# BYLONG COAL PROJECT

Environmental Impact Statement  
Supplementary Response to Submissions  
August 2016

Response to  
Department of Primary  
Industries - Water  
Submission

**Bylong Coal Project  
Response to Department of Primary Industries – Water Submission, Dated 12 May  
2016**

FIGURE No:  
**3-1**

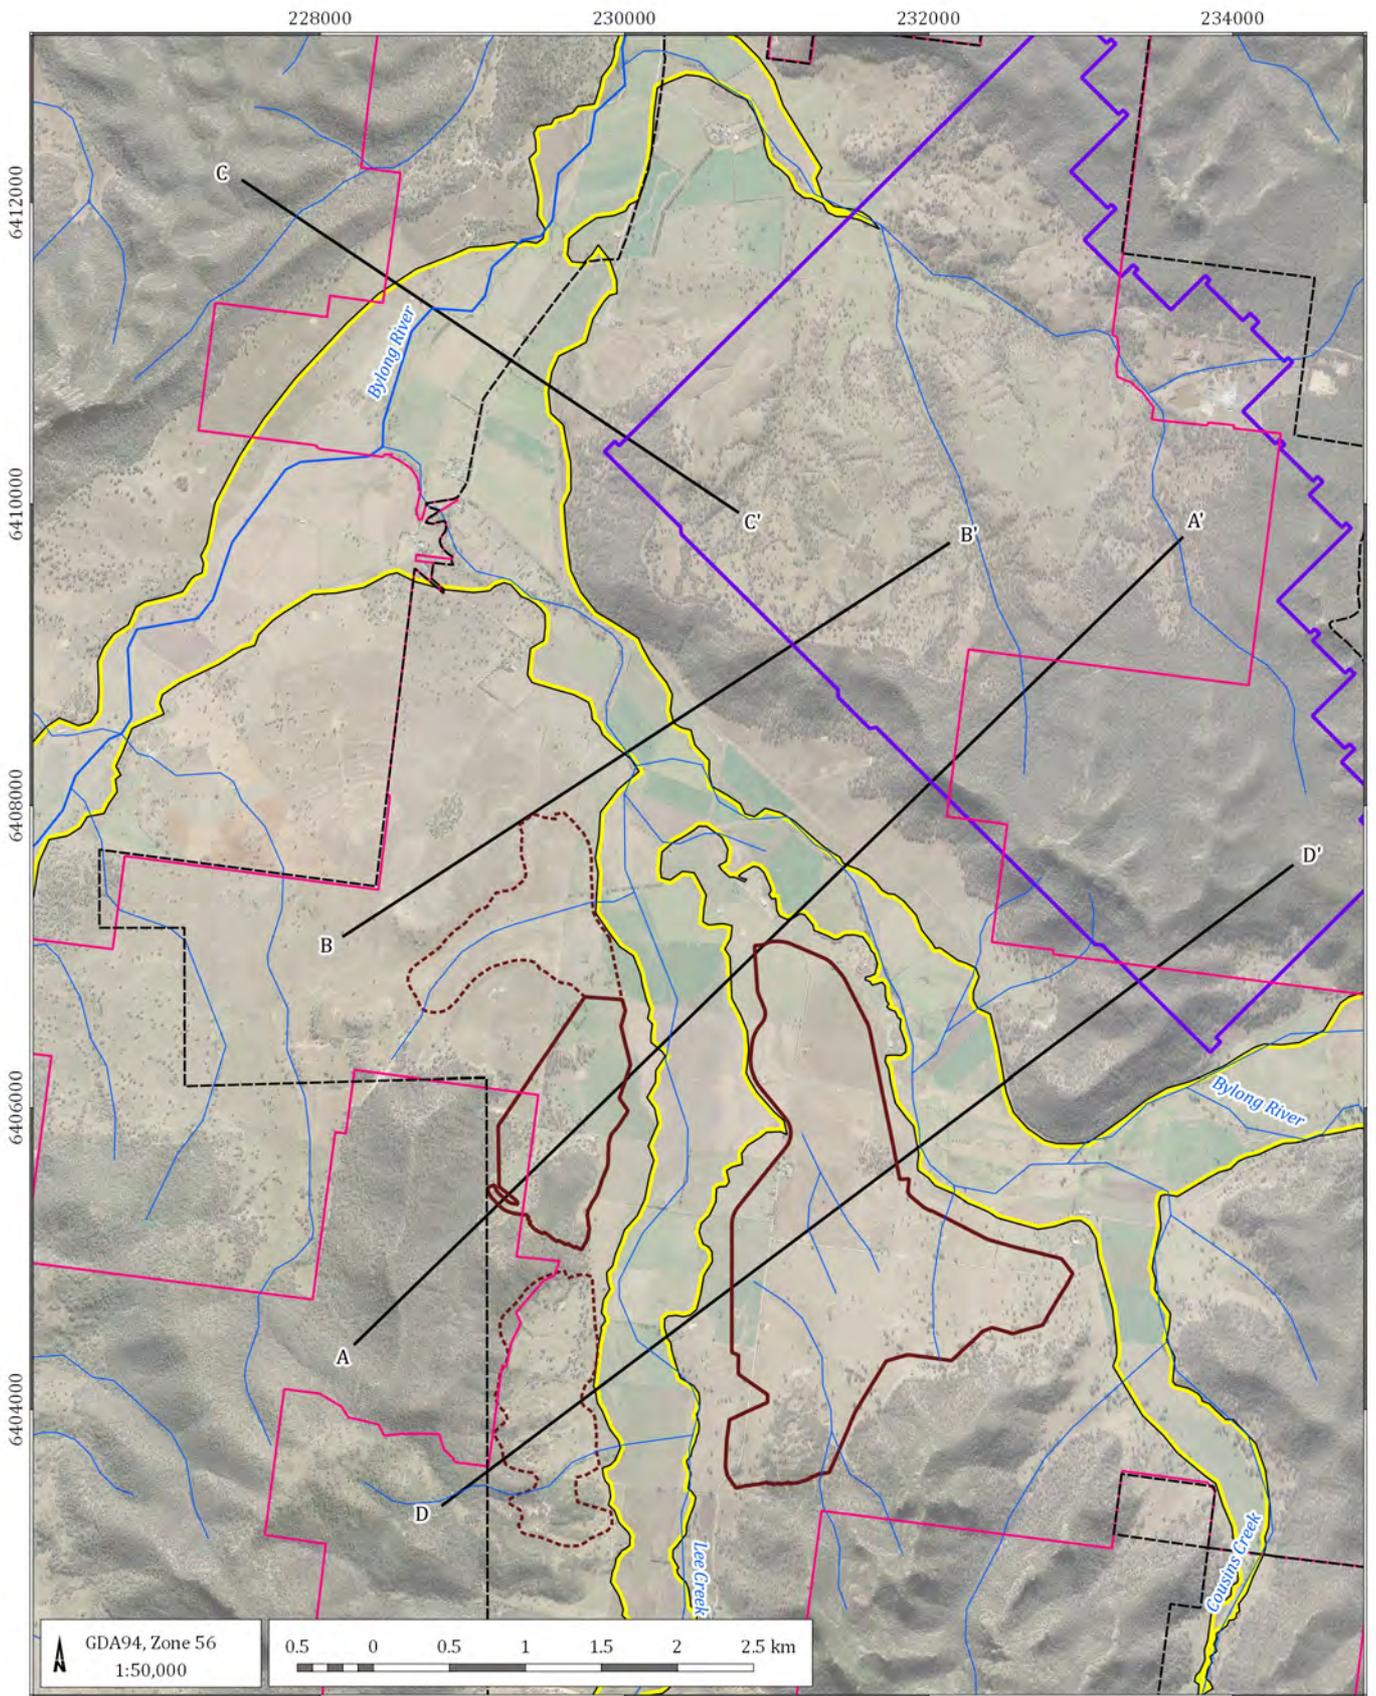
To address this request the cross sections through the alluvium provided in the RTS were increased both laterally and vertically to incorporate the Permian strata, the catchment area contributing streams and the proposed mining and emplacement areas. A new cross section was also provided through the proposed open cut and underground mining areas further south and upstream.

Figure 3-1 shows the locations of the cross sections, whilst Figure 3-2 to Figure 3-5 shows the geological units along each cross section line. The cross sections are based on the groundwater model and therefore show the stratigraphic unit(s) each model layer represents. Adjacent monitoring bores are projected onto each cross section.

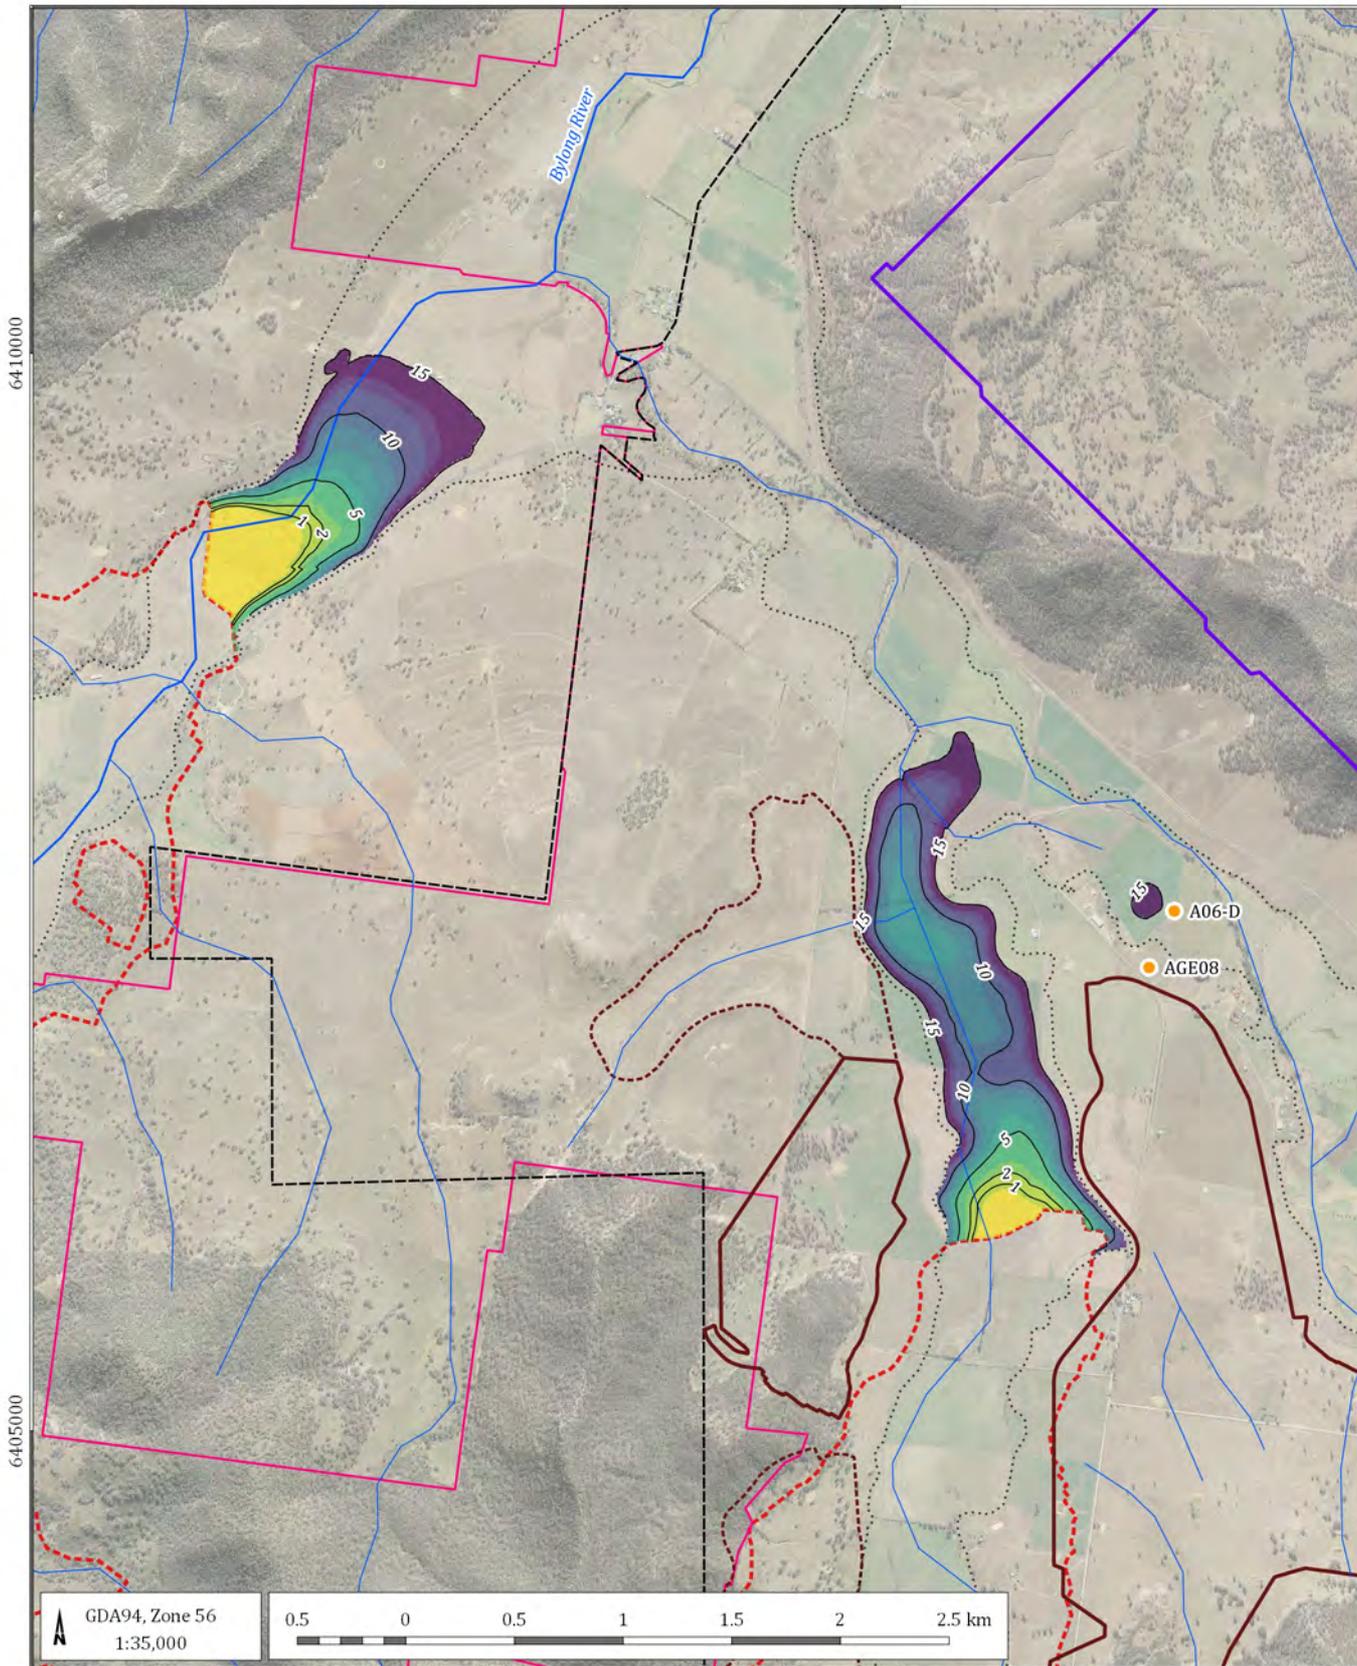
DPI Water interpreted from maps presented within the RTS document that a hydraulic connection between the Quaternary alluvial aquifer and the Coggan Coal seam aquifer was likely to exist. It is agreed that the available data does indicate in some areas there is a direct or direct hydraulic connection between the alluvium and the coal seams proposed to be mined. Figure 5-19 shows where the Coggan Coal seam either subcrops below the alluvium, or outcrops close to the land surface. The areas where the coal seam subcrops directly beneath the alluvium, or is separated by a thin layer of weathered Permian sediments will be areas where the connectivity is enhanced. Figure 5-19 shows this occurs primarily in the area of the Lee Creek alluvium between the Eastern and Western open cut mining areas. Towards the south of this area the coal seams outcrop above the water table and therefore do not have any direct connection with the alluvial aquifer.

**Figure 6-22 Uncertainty in borefield yield**

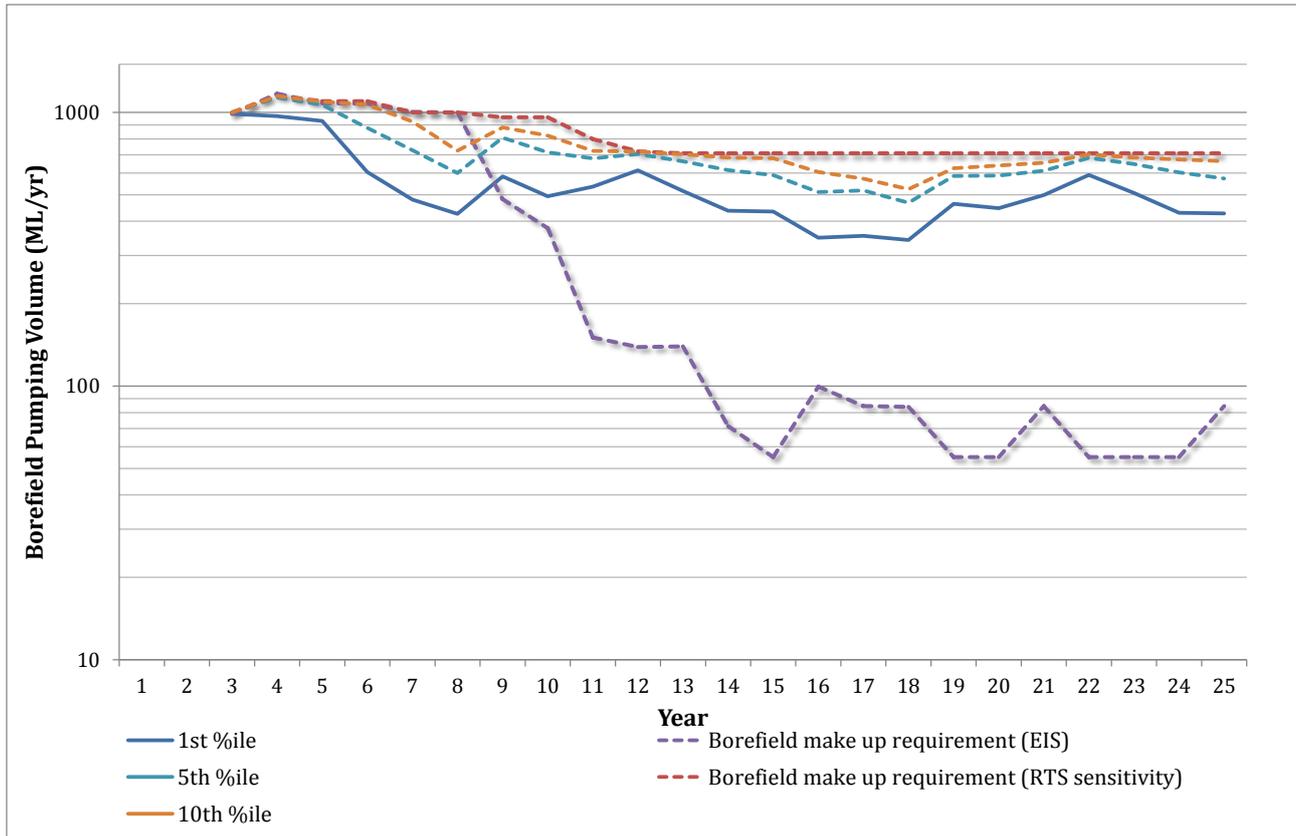
The uncertainty analysis comprised 140 separate model runs with parameters varying randomly between the ranges outlined within Section 6.4.4. The yield from the proposed borefield was extracted for each model run to determine the potential to meet the estimated demand for makeup water. The data from the 140 model runs was used to calculate the proportion of the 140 model runs that failed to meet the upper makeup water demand presented within the RTS. Figure 6-22 shows the estimated makeup water demand presented within the EIS and RTS as well as the percentage of model runs that fell below the make up water demand.

Figure 6-22 indicates the borefield in the majority of the model runs was capable of supplying the make up water estimated within the RTS as a sensitivity. The figure shows the 1<sup>st</sup> and 5<sup>th</sup> percentiles for borefield pumping fall slightly below the RTS sensitivity make up water demand, with the 10<sup>th</sup> percentile falling below the demand intermittently.

Figure 6-22 indicates when the model is recalibrated to account for the higher hydraulic conductivity and storage determined from the pumping test program, the potential for the borefield to supply the make up water increases significantly. The basecase model can supply the make up water along with the majority of the models developed for the uncertainty analysis. This was achieved with a reduced borefield of eight bores installed within the alluvials throughout the Project Boundary. In the unlikely scenario that the borefield cannot meet the demand for make up water, there remains sufficient area to augment the borefield with additional bores. It should be noted that the scenarios where the borefield does not supply the entire makeup water demand are the extremes in both the groundwater and surface water models. Therefore, this outcome is improbable. However as noted in the RTS, should climatic conditions limit yield from the borefield, there will be appropriate contingency measures to implement.

**Figure 4-1 MS Model A^ Layer 1 Distribution of RIV Cells**

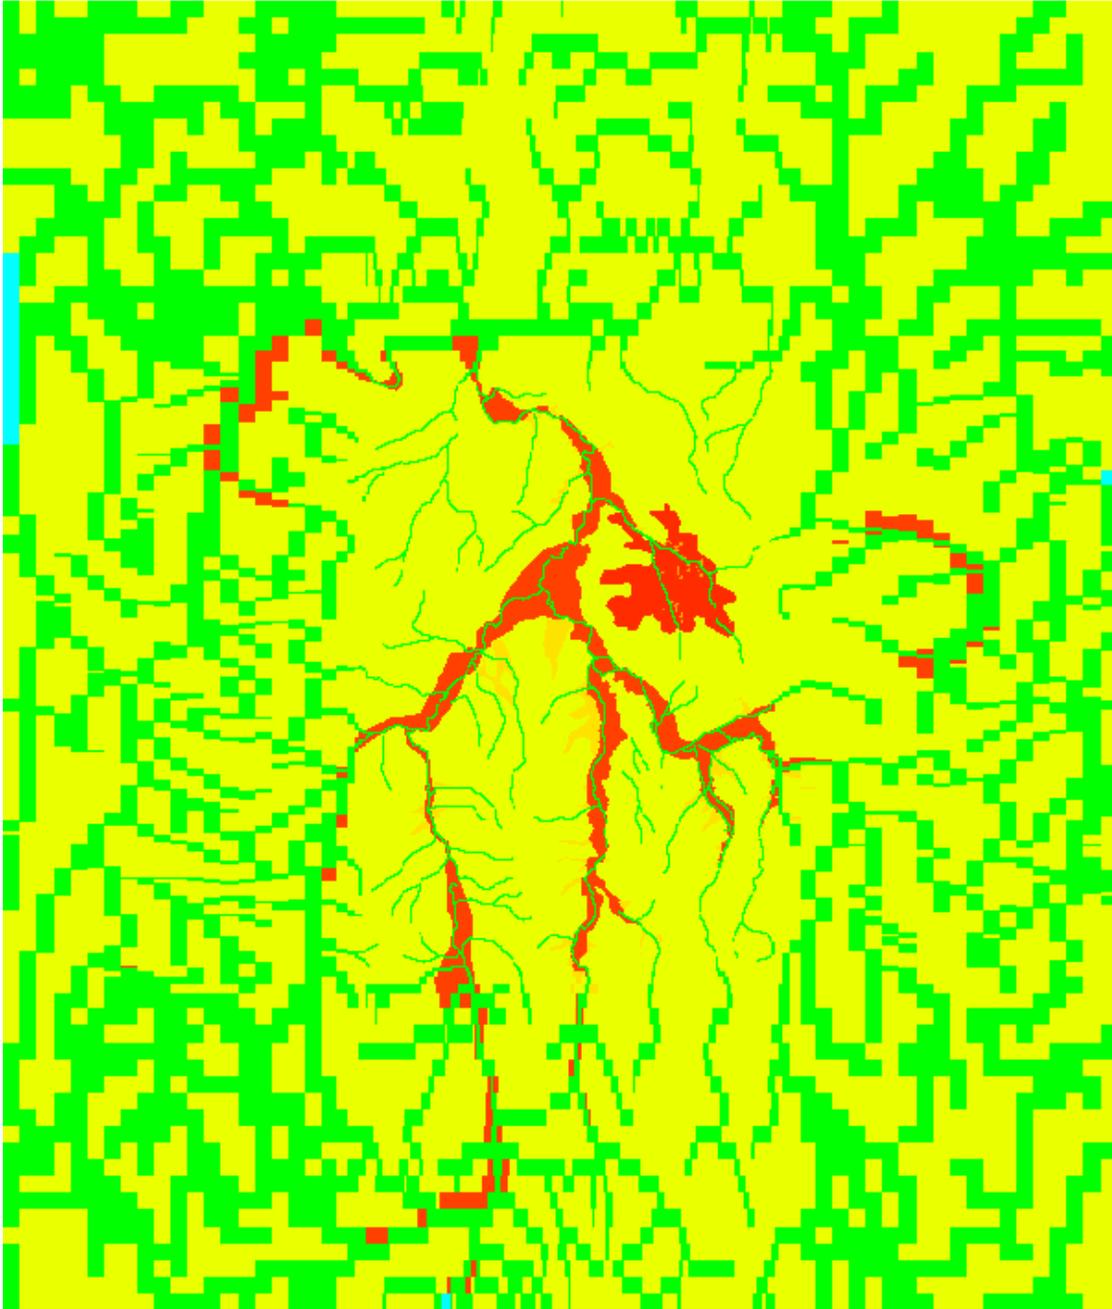
The Layer 1 groundwater heads are controlled by a large number of river (RIV) cells that occupy 12% of the layer cells, as illustrated in **Figure 4-1**. There are instances of strong hydraulic conductivity contrasts within a layer, such as the horizontal hydraulic conductivity (Kx) in Layer 3 shown in **Figure 4-2**. There is also evidence of a dendritic signature surviving down to Layer 6 (**Figure 4-3**) and the coal seam Layer 8.

Figure 4-4 MS Model A^ Layer 3 Distribution of S

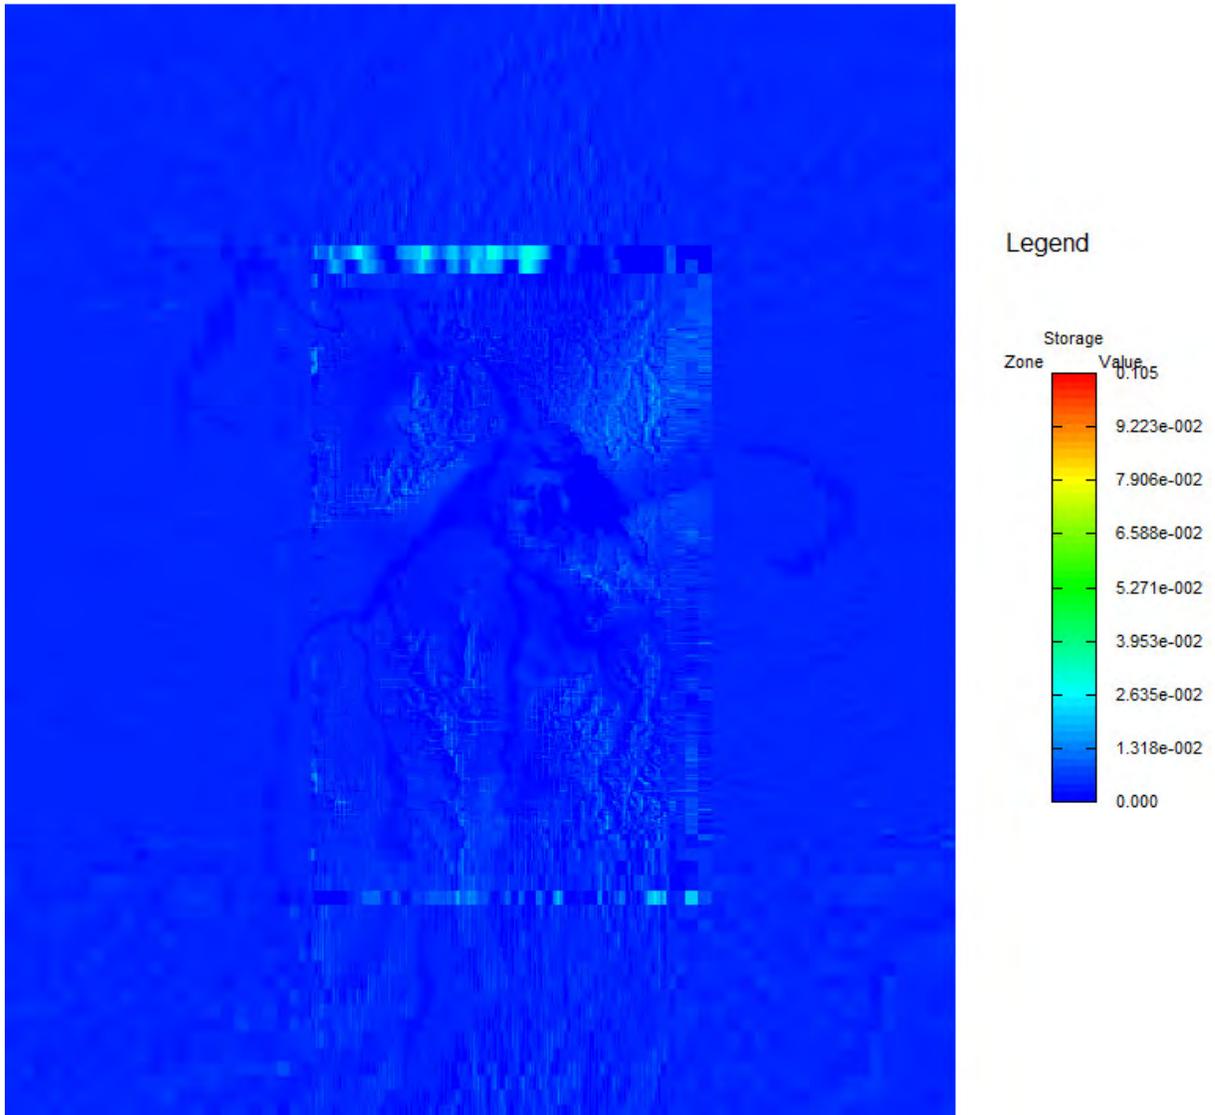
The storage property is defined as the storage coefficient (S) rather than the specific storage (Ss). Again, comparison with USG is made difficult as USG defaults to the use of Ss. While other layers have a sensible distribution for S, Layer 3 has some anomalies that are shown in **Figure 4-4**.
